**Engineering Support Services and Recommendations for Roadside Safety Issues or Problems
for Member States**

Pooled Fund Program TPF-5(501)

Engineering Opinion No. 202403B

W-BEAM GUARDRAIL TRANSITION POSTS IN FLUME ADJACENT TO BRIDGE RAIL

Figure 1. TDOT Guardrail Transition to Concrete Parapet for Highspeed Roadways – Standard S-GRC-4.

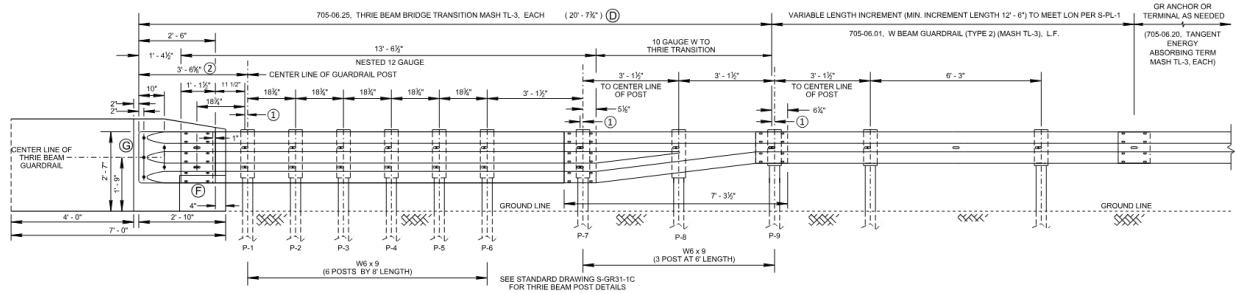
TDOT's standard W-beam guardrail to concrete parapet transition design is shown in Figure 1 (TDOT Standard S-GRC-4). It is comprised of the W-beam guardrail system transitioning to a nested three beam guardrail section via a shape transition section. The nested three beam section is then attached to the concrete parapet. The post spacing is reduced over the span of the transition such that the six posts adjacent to the concrete parapet are installed with 18.75-inch quarter post-spacing (Figure 1). These posts are installed with an embedment depth of 64 inches.

Figure 2. Modification of the Standard Transition Design with Posts Installed in Flume.

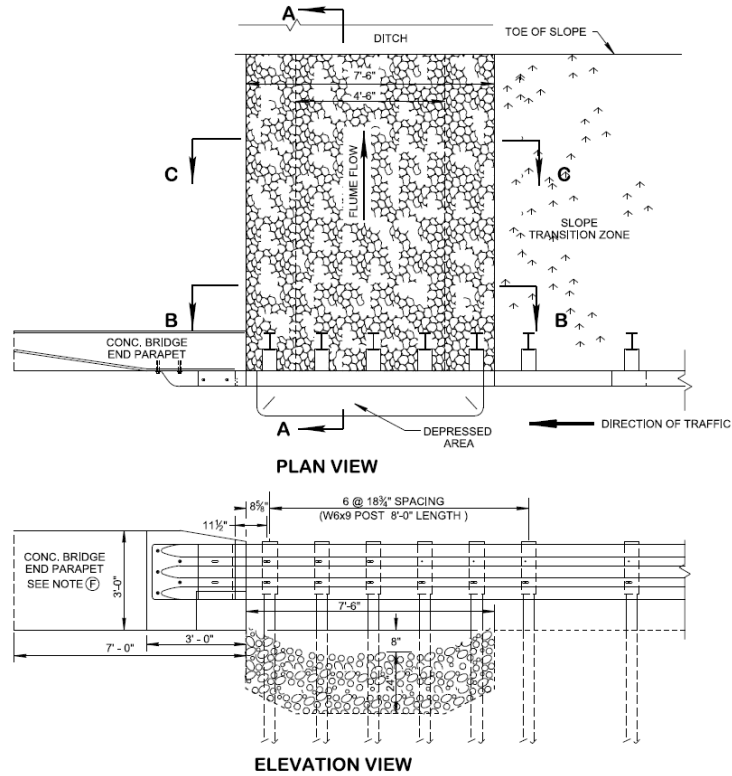
Figure 2 shows the five posts adjacent to the concrete parapet that need to be installed in the flume material. The effect of these posts being installed in flume instead of soil is assessed herein.

For the reasons described above, it can be concluded that by installing the five posts adjacent to the concrete parapet in flume, as shown in Figure 2, the crash performance of the guardrail to concrete parapet transition design is not expected to deteriorate.

Based on the discussion presented herein, it can be concluded that installing the five posts adjacent to the concrete parapet in flume material, as shown in (Figure 2) is not expected to deteriorate the crashworthiness performance of the transition system. For lower-speed design of the transition (Figure 3), additional nested thrie beam section should be added adjacent to the concrete parapet, and only the posts in this additional section may be installed in flume to retain the crashworthiness performance of the upstream W-beam to thrie-beam transition.

Figure 3. TDOT Guardrail Transition to Concrete Parapet for Low Speed Roadways – Standard S-GRC-6.

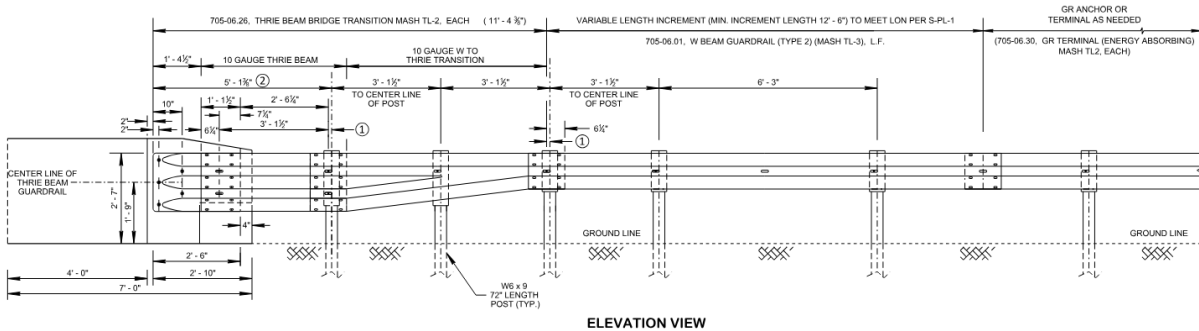
For this system, the posts adjacent to the concrete parapet are in the region of the upstream approach transition where the W-beam section transitions to the thrie beam section via a shape transition section. This upstream transition section has been tested at MASH TL-3 and there was lateral movement of the posts observed in the MASH testing (2). While acknowledging that the TL-2 impact speed is significantly less than the TL-3 impact speed (45 mph vs. 62 mph), since this upstream transition has not been tested with stiffer posts, it is not recommended to install posts in flume in this region without further crash testing.

If the TL-2 transition is extended by adding additional nested thrie beam section and posts installed in flume downstream of the post shown adjacent to the concrete parapet in Figure 3, the modified system would be considered MASH TL-2 compliant. Addition of the posts in flume downstream

from the W-beam to thrie beam shape transition is not expected to negatively impact the performance of the transition at TL-2 speeds.
